Radiation Safety Engineering Assessment Report for the Rapiscan Secure 1000 in Single Pose Configuration

NSTD-09-1085

October 2009

U.S. Department of Homeland Security
Transportation Security Administration
Office of Security Technology
701 South 12th Street
Arlington, VA 22202

Figure 8-10. Locations of Highest Radiation Readings

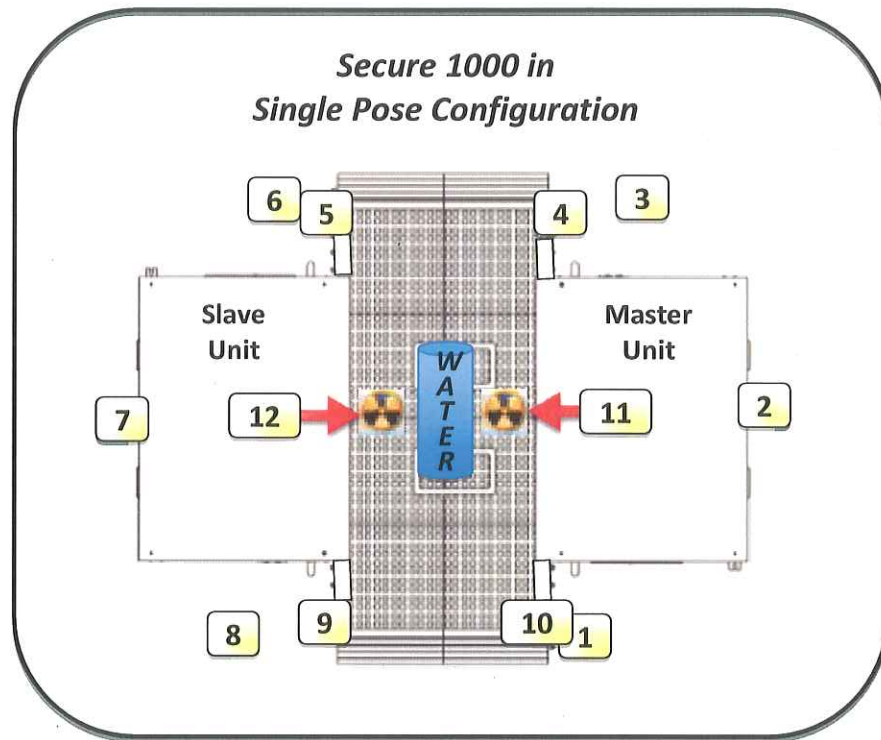
Table 8-7 provides the exposure and background readings for the master unit and Table 8-8 provides the readings for the slave unit. Figure 8-10 provides the locations of the readings. As shown in Table 8-7 and 8-8, the dose above the units (b) (4)

Figure 8-11. Dose to General Public Above Units

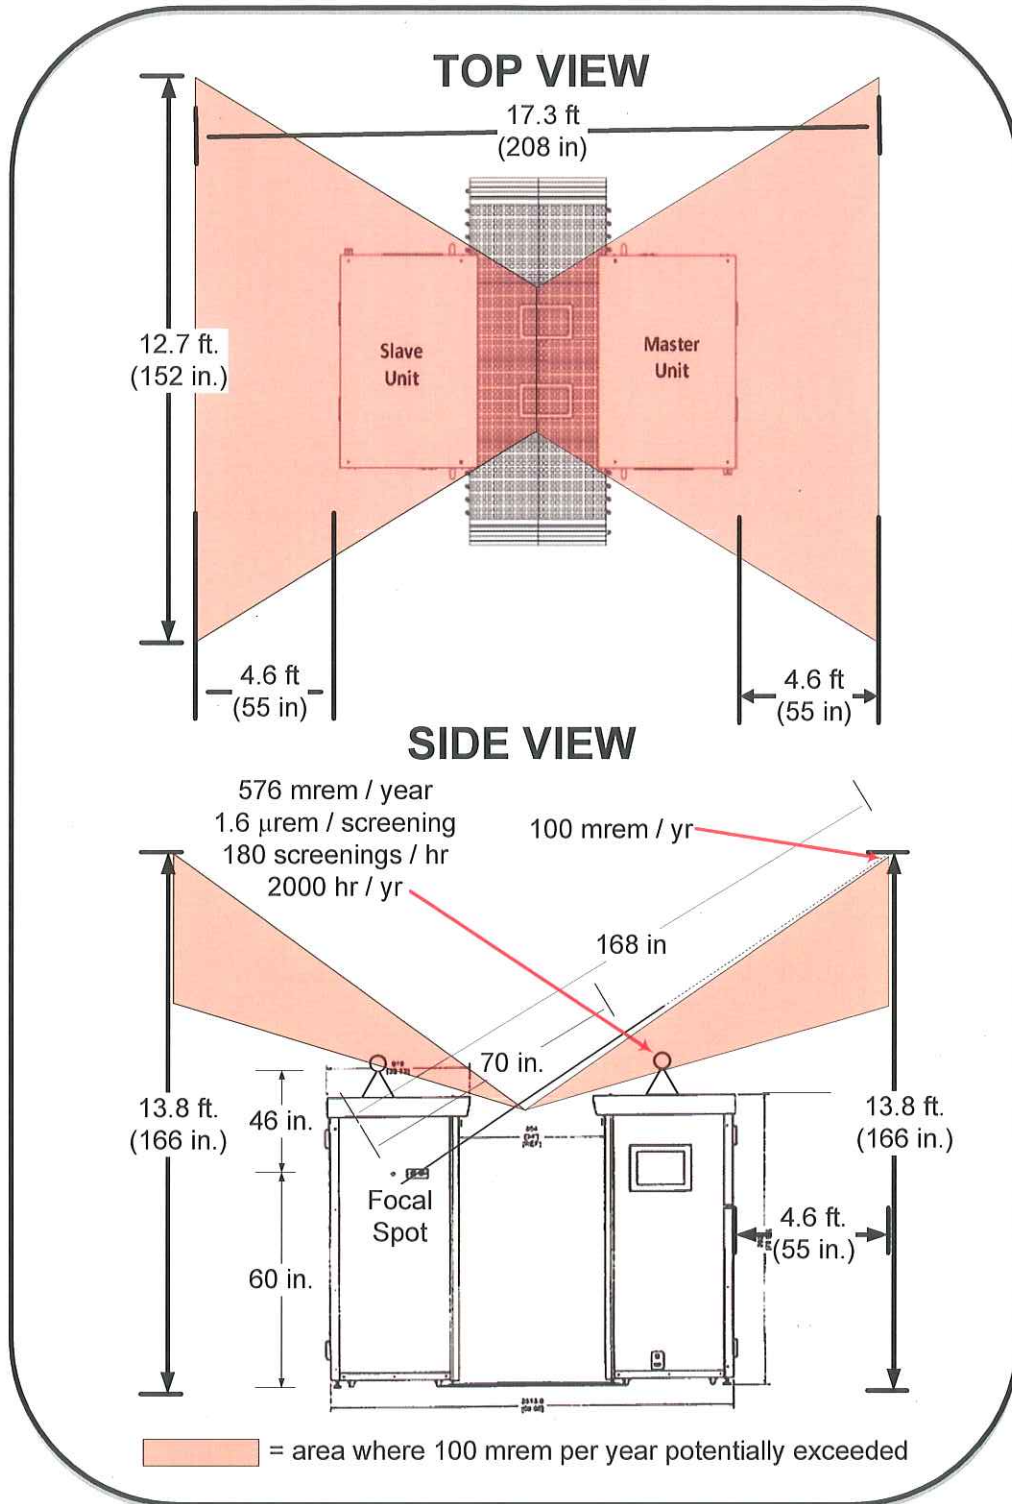
- An area exists above each of the units, due to primary beam overshoot, where the 100 mrem per year general public dose limit could potentially be exceeded. This area extends up to a height of about 14 ft and 4.6 ft behind each of the units.

Based on the data collected during the area survey as described in Section 8.6.1, dose to the general public was determined. An area above the units could potentially exceed the 100 mrem per year general public dose limit, as shown in Figure 8-11. This area extends to a height of approximately 14 feet from the ground and approximately 4.6 feet behind the units. Using the maximum dose of 1.6 μ rem/screening (reference Table 8-7) at a location above the slave unit and using approximate geometric measurements of the X-ray beam path the distance at which the general public dose limit of 100 mrem/year was determined. These measurements assume 180 screenings per hour (30% duty cycle) and 100% occupancy for 2000 hours. It should be noted that this is a conservative assumption based on the maximum dose of 1.6 μ rem/screening. As discussed in Section 8.6.1, the dose per screening above the slave unit was found to be dependent on the vertical motion of the X-ray generator. Doses are higher when the X-ray generator (b) (4)  as shown in Table 8-7 and 8-8.

- For the area above the units, a beam stop may be considered to ensure the general public dose is maintained.
- The dose to bystanders is within the requirements of ANSI/HPS N43.17-2002, 5.4 and ANSI/HPS N43.17-2009, 6.2:

Figure 8-12. Dose to General Public at Entry and Exit Locations

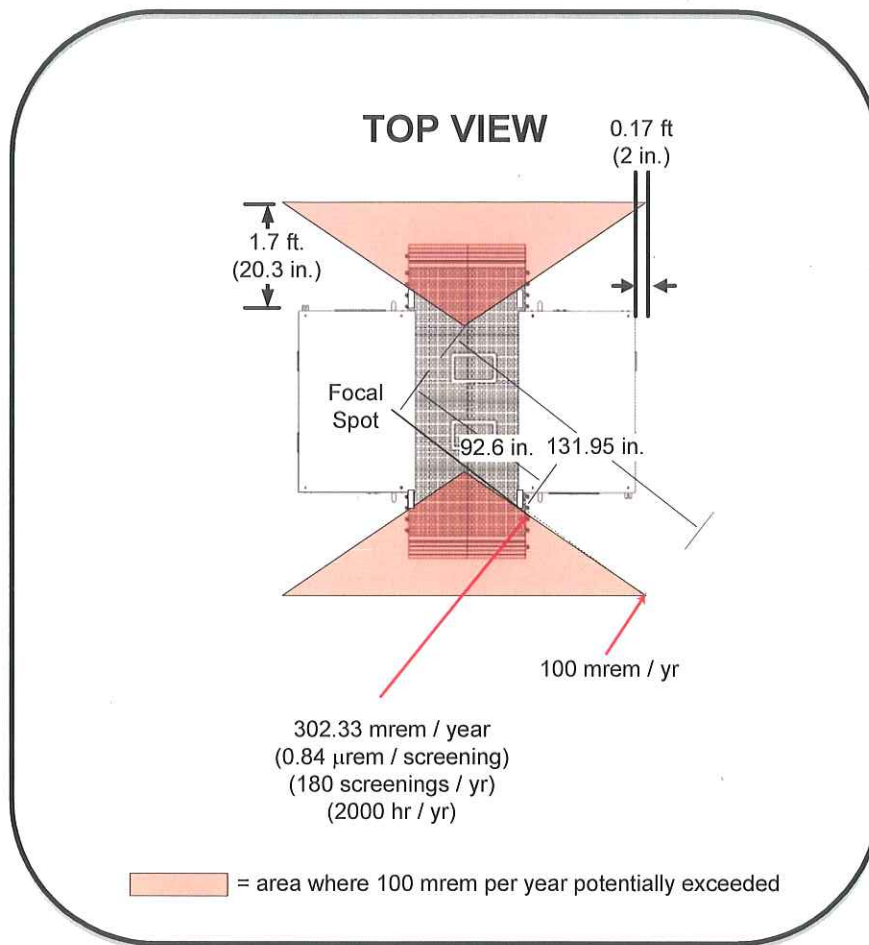
- A second area exists at the entry and exit locations of the scan area, where the 100 mrem per year general public dose limit could potentially be exceeded. This area extends approximately 1.7 ft from the side of the units at the entry and exit locations.

Using the maximum average dose measurements from the wing locations, an area that extends 1.7 feet from the sides of the units at the entry and exit locations could potentially exceed the 100 mrem per year general public dose limit, as shown in Figure 8-12. Using the maximum average dose measurement of 0.84 μ rem/screening and approximate geometric measurements of the X-ray beam path, an approximate 100 mrem/year area was determined. These measurements assume 180 screenings per hour (30% duty cycle) and 100% occupancy for 2000 hours.

- It is recommended that a survey of each installation site be conducted to ensure that the dose to any member of the general public is maintained below the 100 mrem (0.1 rem) per year general public limit and to ensure that doses are kept “As Low As Reasonably Achievable” (ALARA).
